SUBJECT: COMANCHE PEAK STEAM ELECTRIC STATION (CPSES)
DOCKET NOS. 50-445 AND 50-446
REQUEST FOR ADDITIONAL INFORMATION REGARDING
LICENSE AMENDMENT REQUEST (LAR) 01-012
STEAM GENERATOR TUBE REPAIR USING LEAK TIGHT
SLEEVES

**REQUEST FOR ADDITIONAL INFORMATION AND RESPONSES REGARDING
STEAM GENERATOR TUBE REPAIR USING LEAK TIGHT SLEEVES
LICENSE AMENDMENT REQUEST (LAR) 01-012**

Hydraulic Equivalency Number of Tubes with TIG Welded Sleeves for Comanche Peak Steam Electric Station

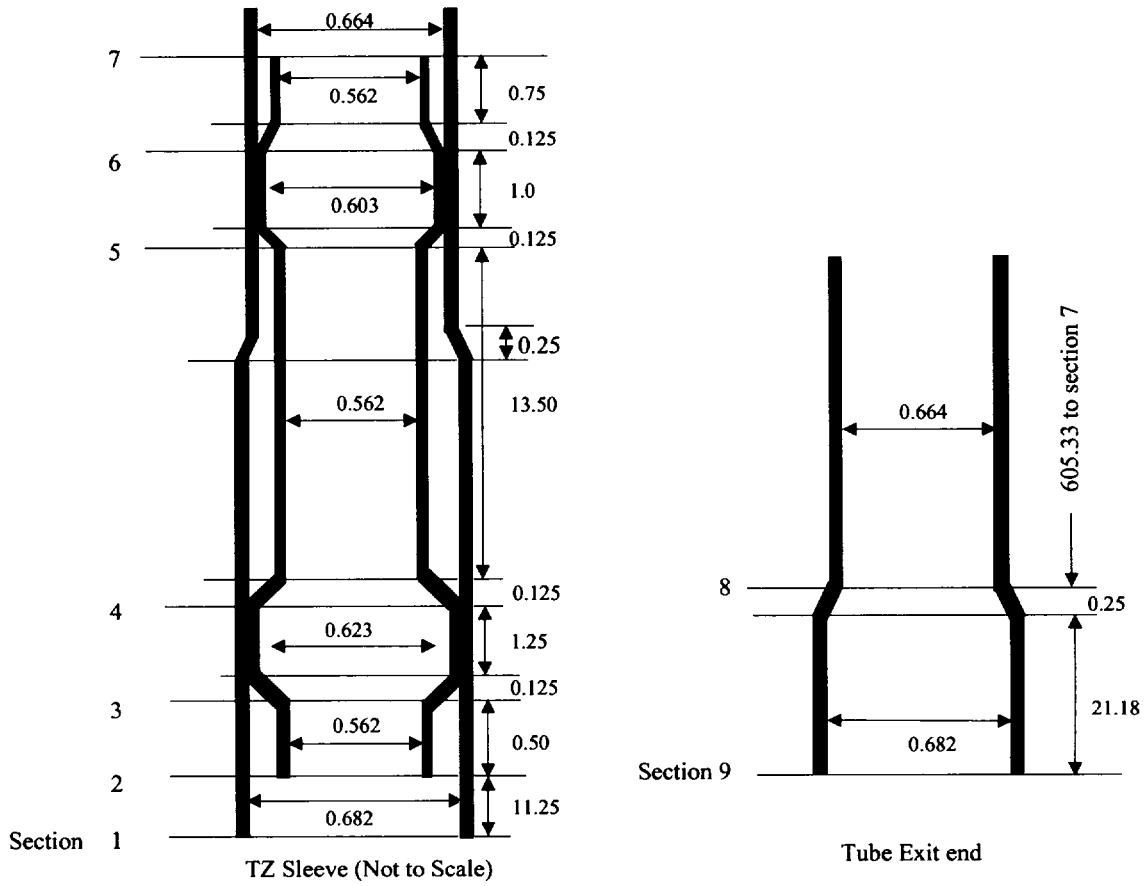
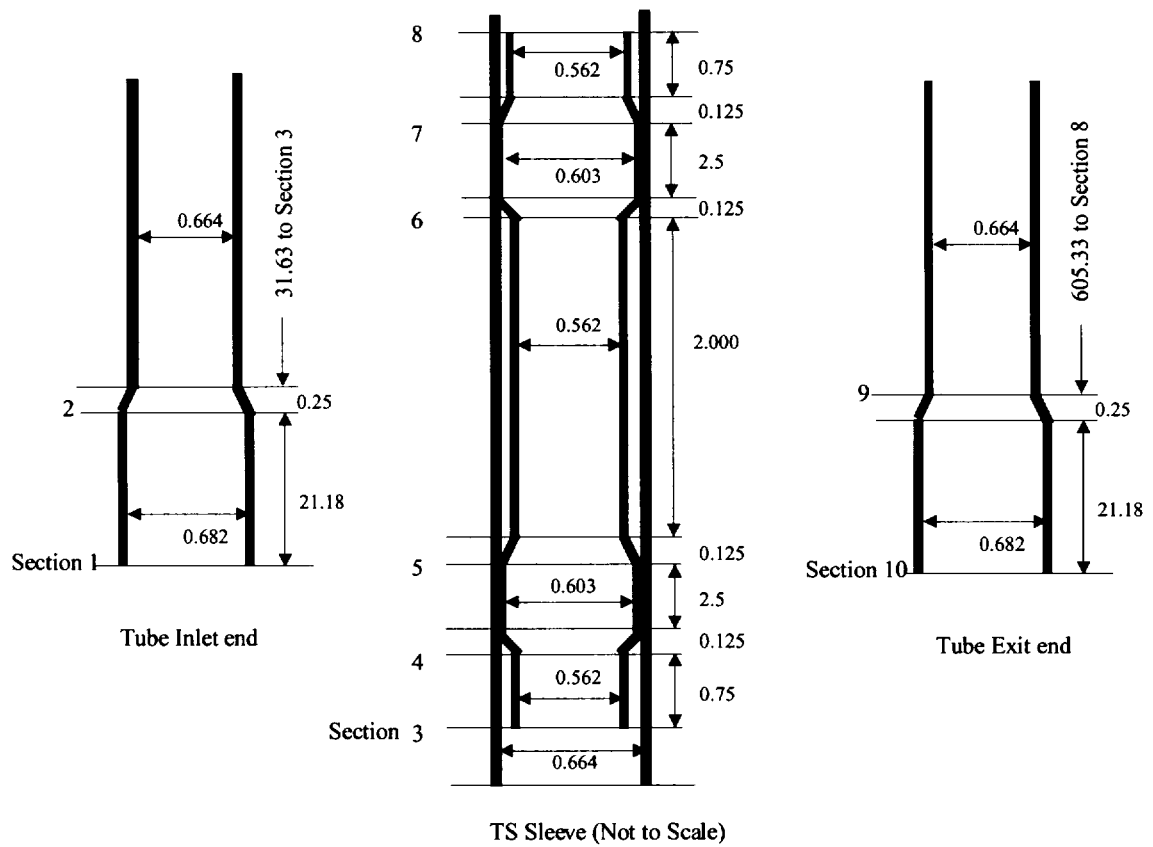
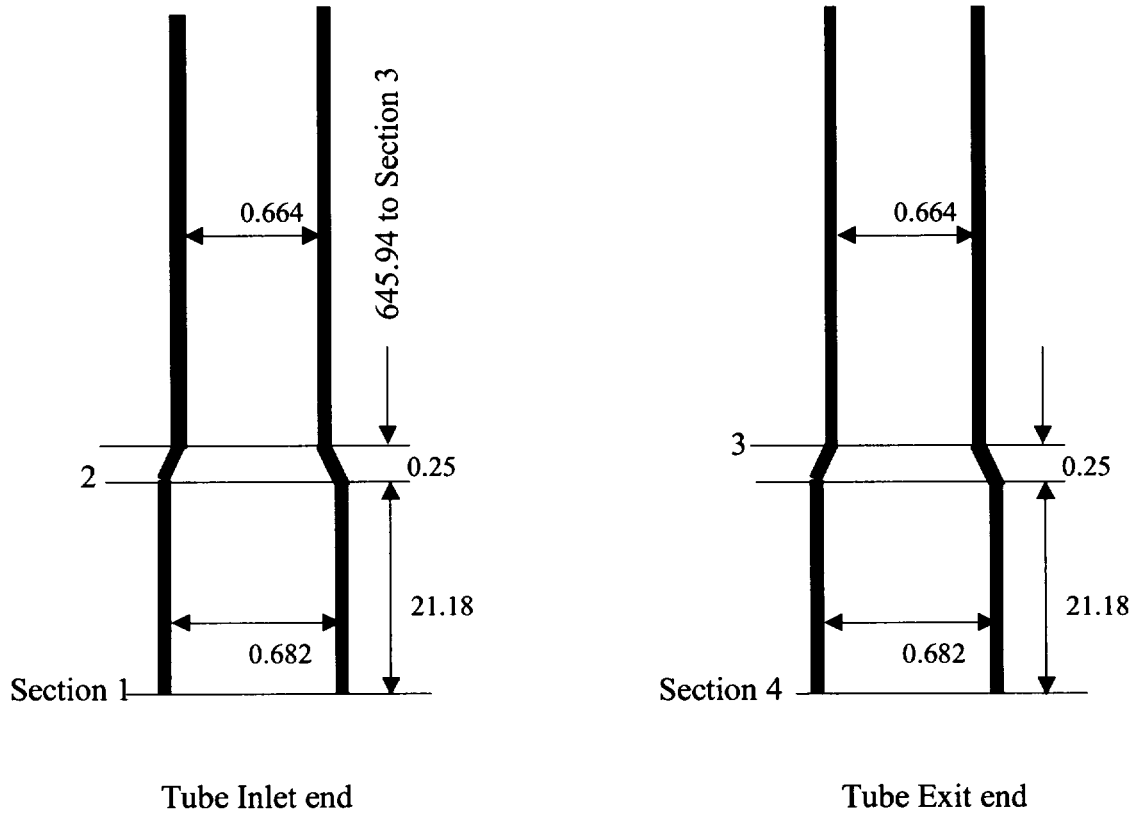
Specify the sleeve/plug ratio applicable to the leak tight sleeves proposed for use in CPSES Unit 1, and discuss the acceptability of the method and assumptions used to determine the sleeve/plug ratio.

Provide the results of hydraulic test data and their comparison with values predicted by the calculational method used to determine the sleeve/plug ratio and identify the associated uncertainties.

There are two types of sleeve that are being considered at CPSES. A description of these sleeves together with un-sleeved tube will be used for calculating pressure loss and thus hydraulic equivalency number. Consistent with Westinghouse drawings of these two types of sleeve, Figures 1 through 3 provide dimensions that are used for the calculation. Figure 1 illustrates the "Expansion Transition Zone Sleeve" (ETZ sleeve) and its location; the ETZ-Sleeve is 17.5 inches long. (The dimensions shown in the figures are not to scale). Figure 2 depicts the "Tube Support Sleeve" (TS Sleeve). The TS-sleeve is 9 inches long. Figure 3 shows the dimensions of the un-sleeved tube for CPSES Unit 1.

Calculations were made for three installations of two types of sleeves, as shown in Figures 1 to 3. Results of loss coefficients for all three installations are listed in Table 2.

Case	Total loss coefficient
Tube without sleeve	12.9662
Tube with ETZ-Sleeve	13.7710
Tube with TS-Sleeve	13.4614
Tube with ETZ-Sleeve plus TS-Sleeve	14.1795

As expected, the ETZ-Sleeve has a higher loss coefficient than the TS-Sleeve. The main cause is not the length, but the contraction loss at the inlet of the sleeve and the lower expansion/rolled loss is much higher for the ETZ-Sleeve. For the same inlet and lower expansion zone, the TS-Sleeve has a larger ratio of diameters between upstream and downstream, and thus loss coefficients are smaller.

Case	Hydraulic Equivalency Number
ETZ-Sleeve	34
TS-Sleeve	54
ETZ-Sleeve plus TS-Sleeve	23
